SALT LAKE CITY HISTORIC LANDMARK COMMISSION REQUEST BY TROLLEY SQUARE ASSOCIATES LLC, REPRESENTED BY MARK BLANCARTE FOR APPROVAL OF AN EXTERNAL STAIRCASE ON THE MAIN BUILDING AT TROLLEY SQUARE LOCATED AT APPROXIMATELY 602 EAST 500 SOUTH. THE PROPERTY IS LOCATED IN THE CENTRAL CITY HISTORIC DISTRICT.

CASE NO. 470-07-08 WEDNESDAY, APRIL 4, 2007

Approximate location of proposed staircase and doorway

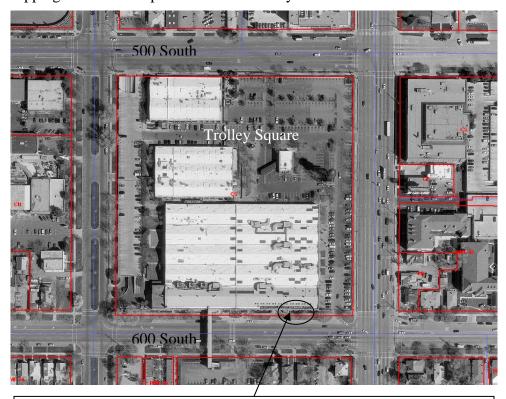
The owners of Trolley Square are proposing to install an external staircase and doorway on the south side of the main building on Trolley Square. The applicants intend to remove two existing external staircases on the southwest corner of the main building and replace them with a single staircase and doorway located on the southeast corner. The proposal is part of an internal remodel that includes some external changes to the main building. This petition is being reviewed by the HLC because it is highly visible and adds a new building element to a landmark site. The property is located in a CS Community Shopping Zoning District. The purpose of the CS Zoning District is to "provide an environment for efficient and attractive shopping center development at a community level scale."
